CITY OF PORTLAND BUILDING PERMIT

Job ID: 2011-10-2463-NEWCOM

has permission to Build a 4,176 square foot rental car maintenance facility and filling station provided that the person or persons, firm or corporation accepting this permit shall comply with all of the provisions of the Statues of Maine and of the Ordinances of the City of Portland regulating the construction, maintenance and use of the buildings and structures, and of the application on file in the department.

Project Name:	ENTERPRISES RENT-A-CAR	Project ID:	2011-246
Address:	1128 WESTBROOK STREET	CBL:	INSERT CBL
Applicant:	ENTERPRISE HOLDING, LLC		
Planner:	SHUKRIA WIAR

SITE PLAN

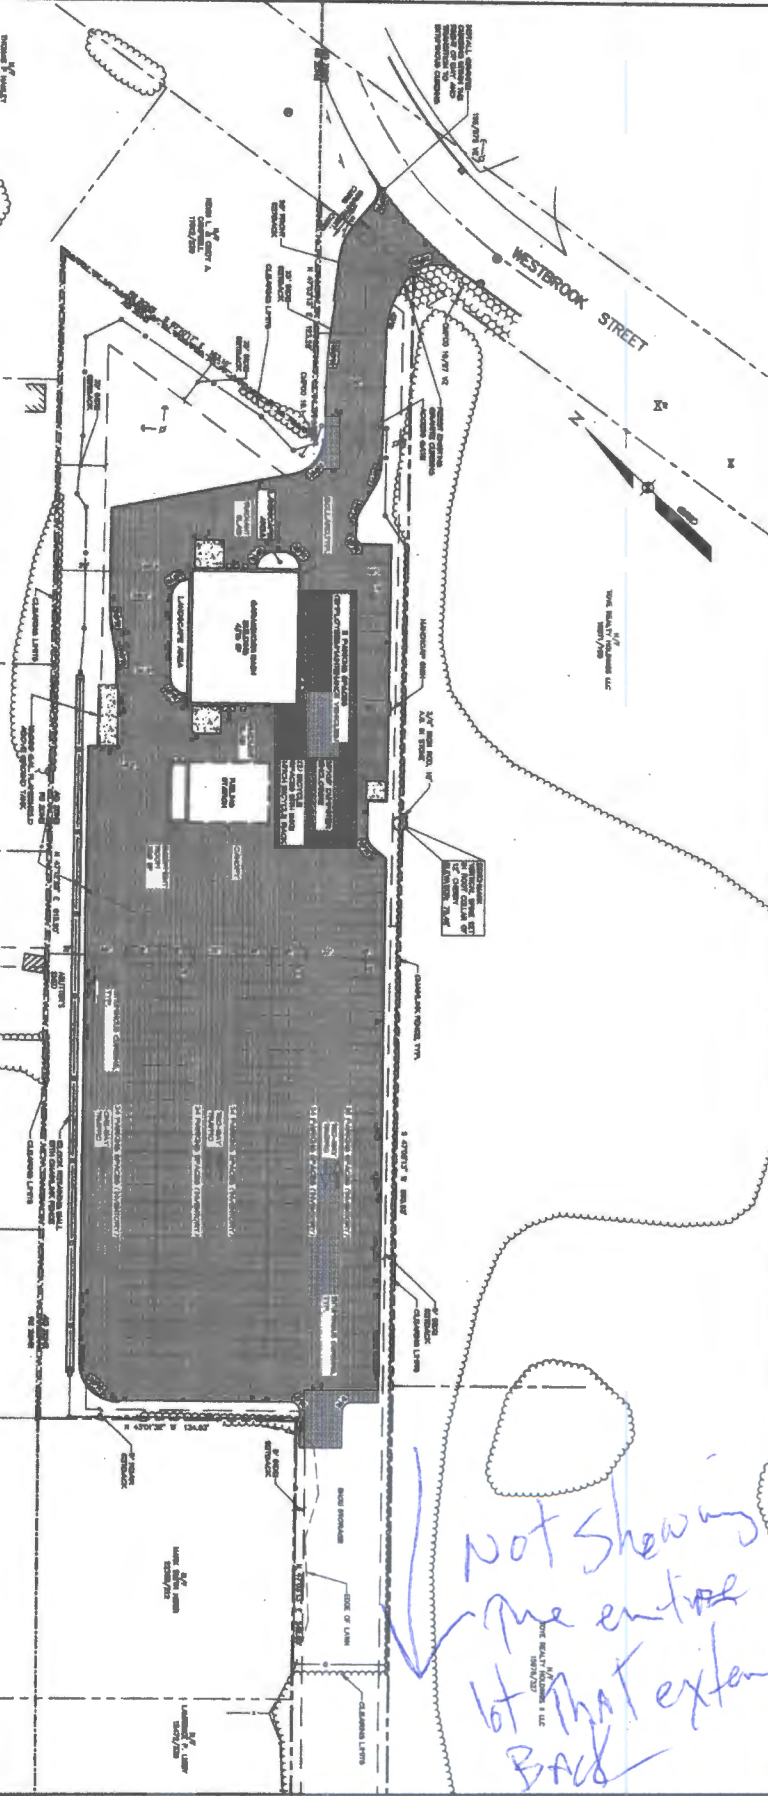
Revised final plans have been submitted and received on 7/20/11. The concept plans have been changed. The setbacks for the new building placement are meeting the AB Zone requirements. The applicant has lessened the post impervious surface. It will now be 59.19%. It is still under the maximum of 70% allowed.

The previous comment concerning maximum dBAs is still in effect and will be checked prior to any unit installation. Cut sheets showing the unit dBAs will be required at that time.
